Product Change Notice (PCN)

PCN Number: PCN-0370542-01

CMT-8504-100-SMT-TR

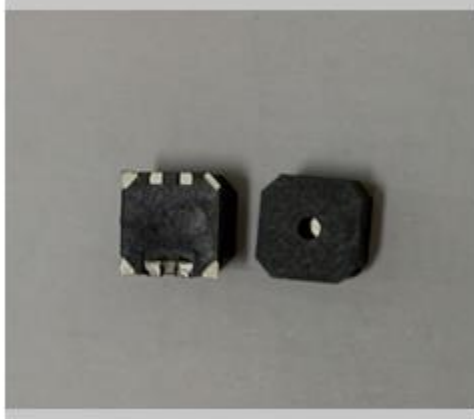
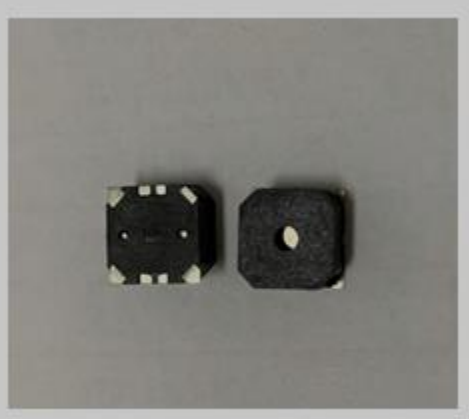
Improving the structure by changing the bottom to integrated with injection molding, and the connection parts being put inside. The item will now be done by machine to increase the capacity of production.

The only change is the injection Molding. This does not change any of the Characteristics of the product.
